Department of Energy
Savannah River Operations Office
P.O. Box A
Aiken, South Carolina 29802

SUBJECT: Sixth Five-Year Remedy Review Report for Savannah River Site Operable Units with Geosynthetic or Stabilization/Solidification Cover Systems (U) Aiken, South Carolina (SRNS-RP-2021-04229, Revision 1, July 2022) (Redline Pages) and Savannah River Site's Responses to the Regulatory Comments on the Revision 0 Document, SEMS Number: 00

Figure 1: Observed Water Levels and Rainfall near P-Reactor Building (105-P) Complex

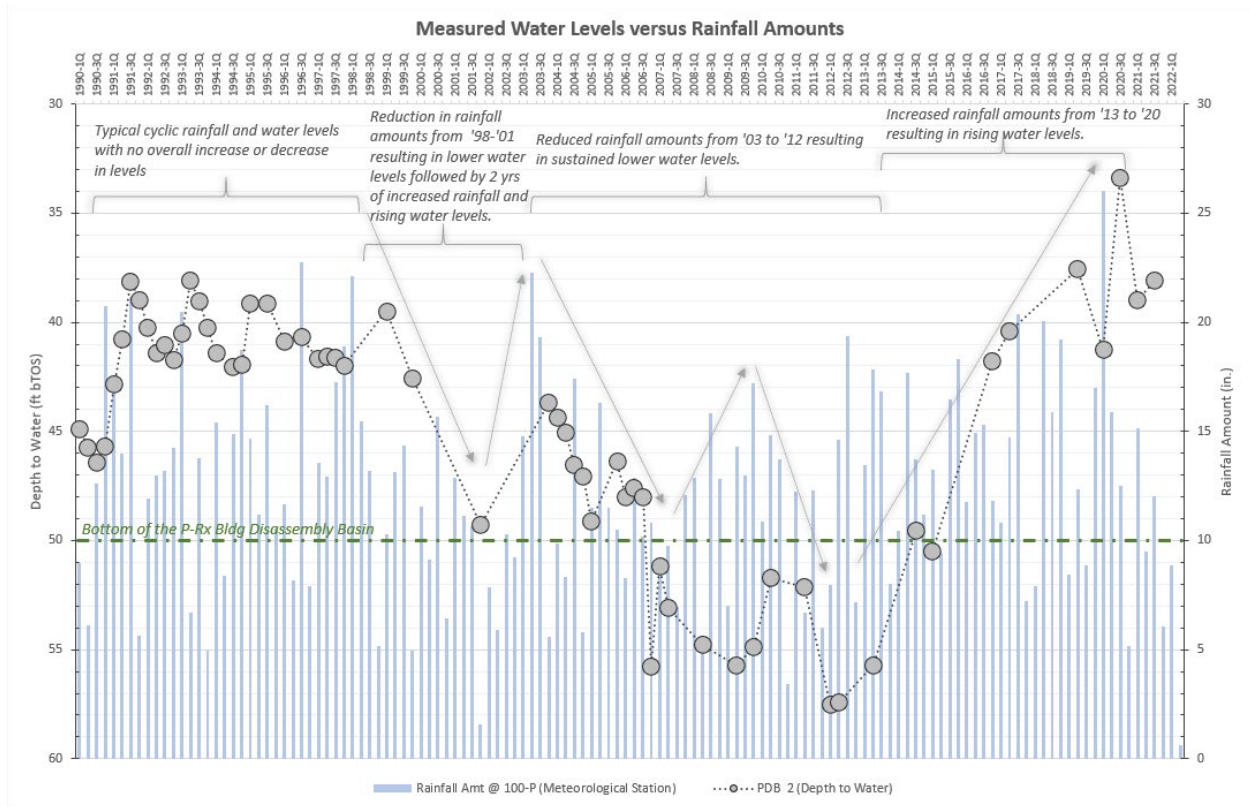
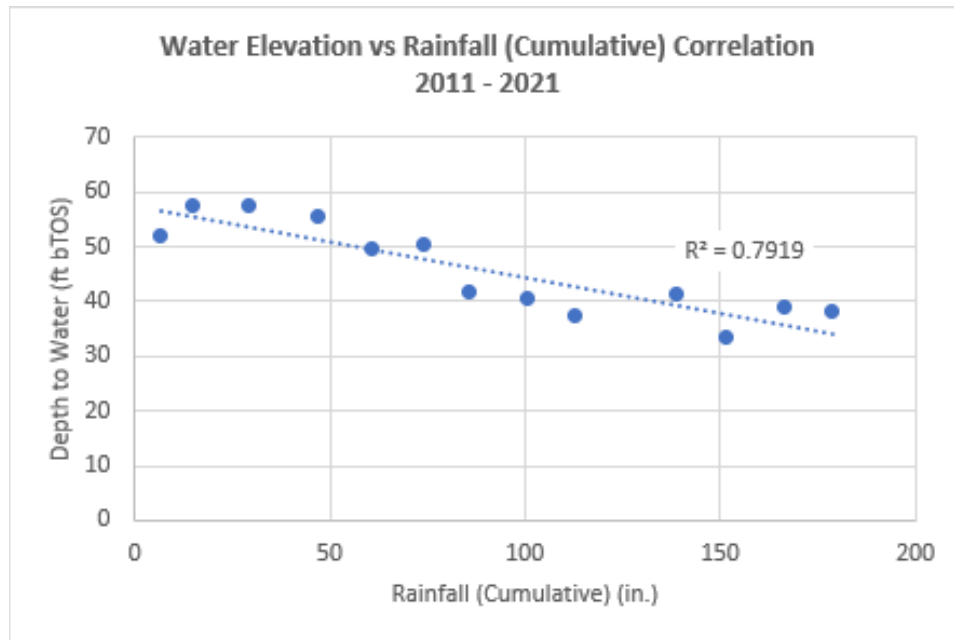
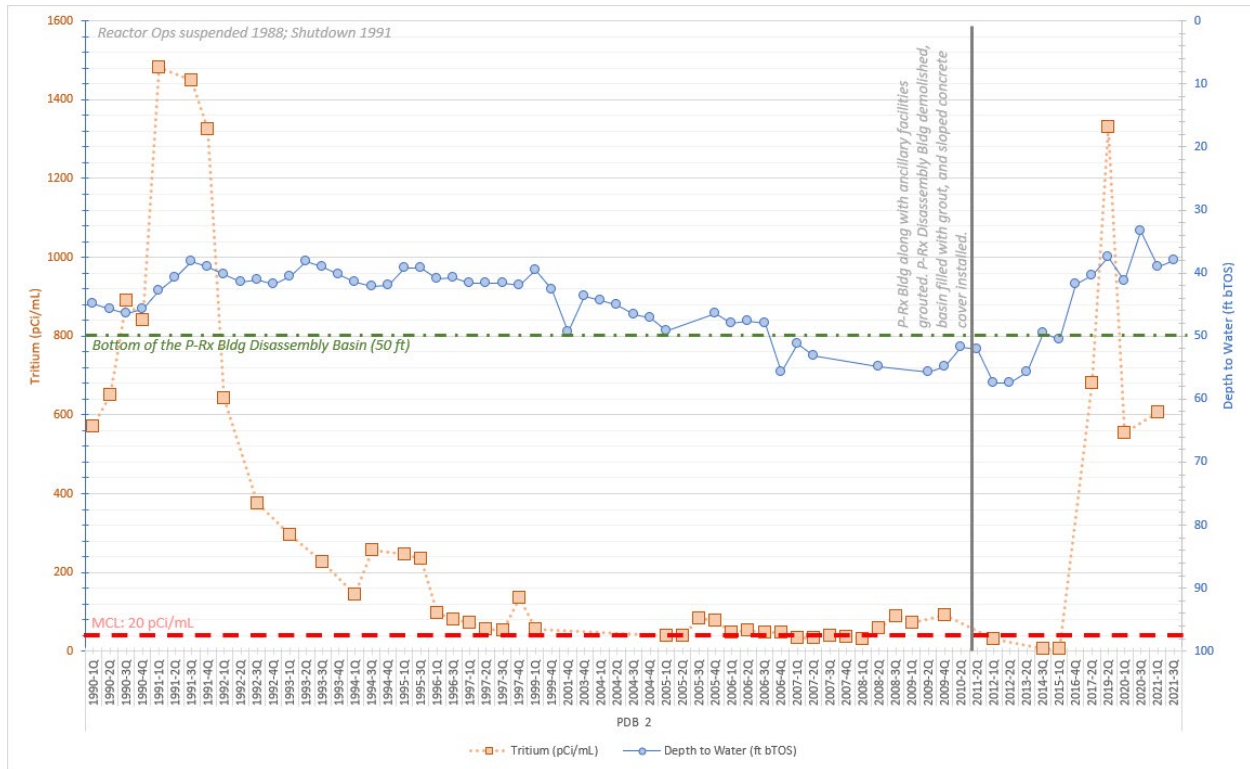
9. **Appendix O, P-Area Operable Unit, Section VII, Technical Assessment, ISD of the P-Reactor Building (105-P) Complex, Page O-16 of O-42:** It is unclear how increases in tritium over time are correlated with a rise in rainfall and water table rises. The text indicates sampling results, since 2017, are shown to have concentration increases for tritium, due to the potential rise in rainfall present in the unsaturated zone that has also increased the water table levels. However, no rainfall or water table level data is presented to support the assertions in the text. *Please revise Section VII to provide the rainfall and water table level data to support the assertion that increased tritium concentrations are correlated with increased rainfall.*

The groundwater wells being monitored as part of the P-Area Operable Unit (PAOU) Effectiveness Monitoring Plan (EMP), particularly related to the P-Reactor Building (105-P) Complex, are completed in the shallow, unconfined Upper Aquifer Zone (UAZ) (e.g., water table). The primary recharge to this aquifer is from rainfall infiltration. Observed increase and decrease in rainfall amounts have a long-term effect on the overall measured water levels of the UAZ surface. These observed changes are illustrated in the graph below.

The data shown in the Figure 1 are from well PDB 2, which is within 20 ft of the P-Reactor Building Disassembly Basin (P-Rx DAB) and included in the PAOU EMP. As illustrated on the figure, changes in cumulative quarterly rainfall have an apparent effect on observed water levels suggesting a strong correlation. This is further supported by a strong correlation between cumulative rainfall with water levels over the last 10 years where an increase in tritium concentrations have been observed (Figure 2).

From 1990 through 2006, observed water levels were shallower than the bottom depth of the P-Rx DAB (Figure 1). The P-Rx DAB is a segmented deep pool with depths ranging from 17 to 50 ft and a total capacity of 4.6 million gallons of water. The water was used as shielding when the irradiated fuel and target assemblies were cooling and being readied for disassembly. Over the course of reactor operations, water from the P-Rx DAB was purged to site streams and the P-Reactor Seepage Basins to maintain clarity. The water would contain radionuclides (e.g., cesium-137, strontium-90, and tritium). Known releases to the environment from process sewer lines have been documented that were associated with operations and maintenance. Additionally, within the P-Rx Building, observed saturation and buildup of leached lime on the concrete walls between the P-Rx DAB and Process Area was known to occur and contained radionuclides similar to the contents within the DAB. It is likely that the same leaching of material was occurring through the P-Rx DAB bottom impacting the subsurface beneath the facility.

Figure 3 illustrates impact to groundwater near the P-Rx DAB with changes in water levels. Of the wells monitoring shallow groundwater as part of the PAOU EMP, this well is the only one that has shown a recent increase in tritium concentrations in the last 6 years. This is primarily due to the increased rainfall and subsequent observed rising water levels. Because it is likely that leached material containing tritium is still present in the subsurface beneath the P-Rx DAB, as water levels rise in the area that was previously dry for nearly 10 years (2006-2016), this area is now re-saturated allowing for tritium to move with groundwater. Previously, because of the lower water levels, these contaminants were not able to migrate.

No changes to the document are proposed.
